**BEFORE THE BOARD OF PATENT APPEALS
AND INTERFERENCES**

Application Number: 10/783,812
Filing Date: February 20, 2004
Appellant(s): GAMMON, BARRY

EXAMINER'S ANSWER

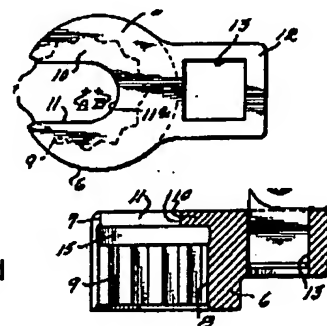
Claims 1 and 2 (as best understood) stand rejected under 35 U.S.C. 102(b) as being anticipated by Johnson, US Patent No. 2,715,347.

Johnson discloses all the limitations, i.e., a socket having a center line (B) and a perimeter (Fig. 3), first face (bottom face as shown in Figs. 2 and 4), an opposite second face, and a receiving slot extending from the first face towards the second including a receiving region (8) adjacent to the first face (first face separated from the second face by web 10) having a center line (A) offset from (B) and includes a step (defined by 10 or 15) against which the connection element rests during rotation of the socket body, and wherein the second face includes a port (13) that does not extend to the first face, having a center line that is not in alignment with the socket body positioned within the perimeter of the socket body.

Regarding claim 2, Johnson meets the limitations.

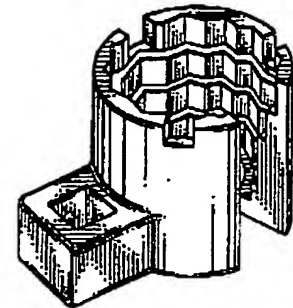
Claims 3-6 (as best understood) stand rejected under 35 U.S.C. 103(a) as being unpatentable over Johnson in view of Farnan et al., US Patent No. Des. 376,521.

Johnson meets all the limitations of the claims except for stepped polygonal and rounded configurations, and wing slots. Farnan et al. teaches stepped polygonal configurations having wing slots. It would have been obvious to one of ordinary skill in the art, at the time the invention was made, to modify the invention of Johnson with the polygonal stepped configuration and wing slots as taught by

Farnan et al. to adapt the tool for driving different sized fasteners and fasteners having wings.

Regarding the rounded configuration claim 5, It would have been obvious to one having ordinary skill in the art at the time the invention was made to make the receiving section rounded instead of polygonal for wing nuts having rounded head, since it has been held that changing shape, dependent on work-piece parameters, involves only routine skill in the art. *In re Stevens*, 101 US PQ 284(CCPA1954).

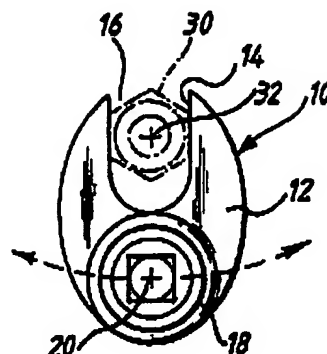
Claims 1-6 (as best understood) are rejected under 35 U.S.C. 103(a) as being unpatentable over Higgins (GB 2 266 257) in view Farnan et al.

Higgins meets all the limitations of the claim 1, i.e., a socket having a center line and a perimeter, first face and an opposite second face, and a receiving slot extending from the first face towards the second including a receiving region adjacent to the first face having a center line that is not in alignment with the centerline of the socket body (Fig. 1) and wherein the second face includes a port (24) that does not extend to the first face of the socket body, the port having a center line that is not in alignment with the center line of the socket body, except for a step against which the connection element rests during rotation of the socket body. Farnan et al. teaches stepped polygonal configurations having wing slots. It would have been obvious to one of ordinary skill in the art, at the time the invention was made, to modify the invention of Higgins with the polygonal stepped configuration and wing slots as taught by Farnan et al. to adapt the tool for driving different sized fasteners and fasteners having wings.

Regarding claims 2-4 and 6, Higgins as modified by Foeman et al. meets the limitations.

Regarding the rounded configuration, claim 5, it would have been obvious to one having ordinary skill in the art at the time the invention was made to make the receiving section rounded instead of polygonal for wing nuts having rounded head, since it has been held that changing shape, dependent on work-piece parameters, involves only routine skill in the art. *In re Stevens*, 101 US PQ 284(CCPA1954).

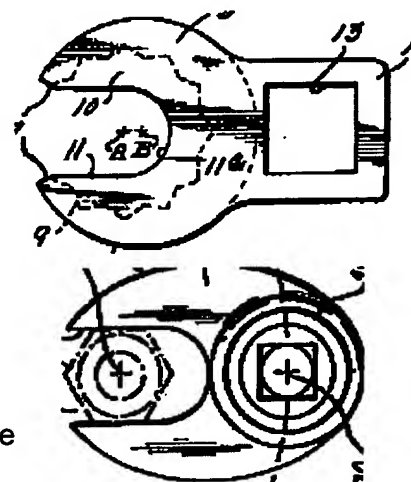
In response to the argument against anticipation, Appellant argues that the port in Johnson is not part of the body, and states that the port is in the handle section and not the head proper or box portion 5 of the wench head. This argument fails to indicate which part of the claim limitations are not met. Whether Johnson discloses an inferior design or not does not further limit the tool as claimed. At best it appears, Appellant reads more into the "body" than recited. Claim recite for the body to have a center line and a perimeter, a first face, an opposing second face and a receiving slot extending from the first face to the second face...the socket body includes a step against which the workpiece rests...and wherein the socket drive port is positioned within the perimeter of the socket body and does not extend above the first face.

Lackign structural limitation and relationship and or clear definitions of the elements, the socket of Johnson meets the "body" as recited. The fact that the port is located on "handle receiving shank" as argued by Appellant, does not exclude the reference, as it appears that Appellant is arguing for the shape of the body, without such limitations recited in the claim. In fact Higgins was cited to emphasis this point, that the port is part of the body.

With regards to the argument that the driver port of Johnson is not the same, because the port in Johnson is through and through, again Appellant is arguing features not recited in the claim. The limitation regarding the port is that it does not extend through to the first face, which is met by the port as disclosed by Johnson. The second face of the socket (the upper surface as

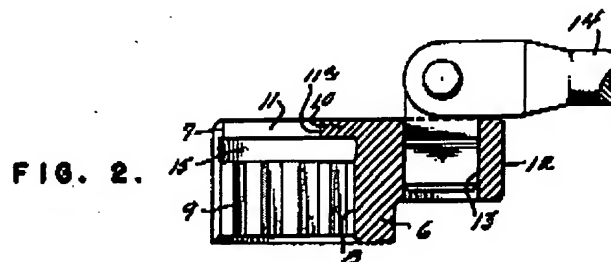
shown here) includes a port (13), which does not extend to the first surface (the lower surface shown here).

The argument against the anticipation is not valid since all the claims' limitations are met, i.e.,

A socket for rotatably loosening or tightening a connection element, the socket comprising a socket body having a centerline (the body has an infinite number of "centerlines", e.g., B which is a lateral center on a line dividing the body symmetrically in half widthwise, or a centerline on a longitudinal line which would be

offset from B towards the port, here B was noted by the Examiner to meet this limitation), a first face (lower surface of cavity as shown here), an opposing second face (upper surface) and a receiving slot

(cavity 8) extending from the first face to the second face, wherein the receiving slot includes a receiving region adjacent to the first face for

receiving and capturing therein the connection element, the receiving region having a centerline (A) that is not in alignment with the centerline of the socket body (e.g., Fig. 3) and includes step (defined by 10 or 15) against which the connection element rests during rotation of the socket body, wherein the second face includes a socket driver port (13) therein that does not extend through to the first face of the socket body (as shown here, extends to a third face but not the first), the socket driver port having a centerline that is not in alignment with the centerline of the socket body (e.g., Fig. 3, shown here), and wherein the socket driver port is positioned within the perimeter of the socket body and does not extend above the first face (e.g. Fig. 2).

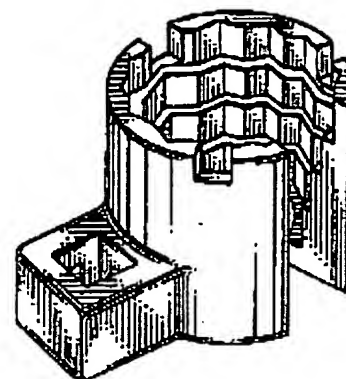
The argument against obviousness rejection over Johnson modified by Farnan is that the port is not part of the body which is not valid as indicated above, since the "body" is not limited in the claims to read over the body as disclosed by either Johnson or Farnan including the port; and that there is no motivation to combine since Farnan is a design patent, and that the steps and the wing slots are shown but are not described in writing. This argument is not valid since not only one of ordinary skill in the art but also an ordinary person through the disclosure of Farnan, e.g., Fig. 1 (shown here) would be motivated and able to improve the socket of Johnson by adapting it for different sizes of workpieces, (stepped configurations) and workpieces having wings (the slots to accommodate the wings).

For Johnson as modified by Makovsky, The Appellant argues against the references individually, that Makovsky does not show the offset centerlines or disclose a basin wrench and that it has a compact design. Makovsky teaches modifying sockets with wing slots to accommodate workpieces having wings of different sizes.

Appellant further characterizes the primary object of the invention of Johnson to be a strong wrench head. Examiner agrees that the two primary objects of the device of Johnson are, a wrench head that resist forces tending to spread the open end of the wrench and wrench heads that prevent slippage. The latter is accomplished by offset center lines (A and B) making it possible to engage the workpiece where the access is difficult and to prevent slippage. With regards to strong head, Johnson discloses the use of a "thickened" wall (6). Modifying the socket with stepped configurations for accommodating different size workpieces, and/or with wing slots (at the distal ends of the wall) for adapting the socket for winged workpieces, in no way compromises the thickened wall as disclosed.

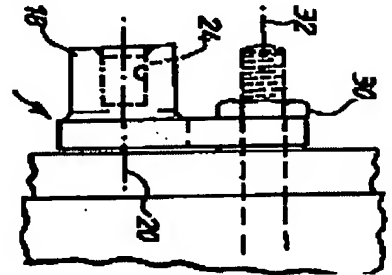
Appellant in arguing against the combination of Higgins and Farnan, states that Farnan does not apply to the present invention, apparently because Farnan is a design patent. Appellant also argues that Higgins would likely teaches away from the modification since its receiving region has a slender construction and it describes the receiving region as having "two parallel sides". This again amounts to piecemeal analysis as references are attacked individually. Higgins does not disclose a stepped configuration, as it is not applied under anticipation rejection. It lacks the teaching for steppe configuration or a step as recited in claim 1 and further lacks the wing slots as recited in claim 4. The question is whether modifying it in view of Farnan et al. is proper. The argument that Farnan et al is a design patent and thus has no written description is not valid since, at least, one of ordinary skill in the art in view of the Farnan's disclosure would be motivated and able to modify the socket of Higgins in adapting it for different sized workpieces (stepped configuration) and slots to accommodate workpieces having wings. The argument against parallel sizes is not valid since Higgins is not concern with adapting the socket for different sizes, the device as disclosed is designed for a specific size. But there is nothing to exclude one of ordinary skill in the art to improve upon the socket by adapting it for different sized workpieces in view of Farnan et al. The argument that the receiving region and the driver port of Higgins are aligned with each other and thus the modified references would not meet all of the claims limitations, is in error. The receiving region of Higgins is offset from the driver port as shown e.g., in Fig. 2. Further the argument that "the socket driver port of Higgins extends beyond the face of the socket body" is invalid, because such limitation is not recited in the claims.
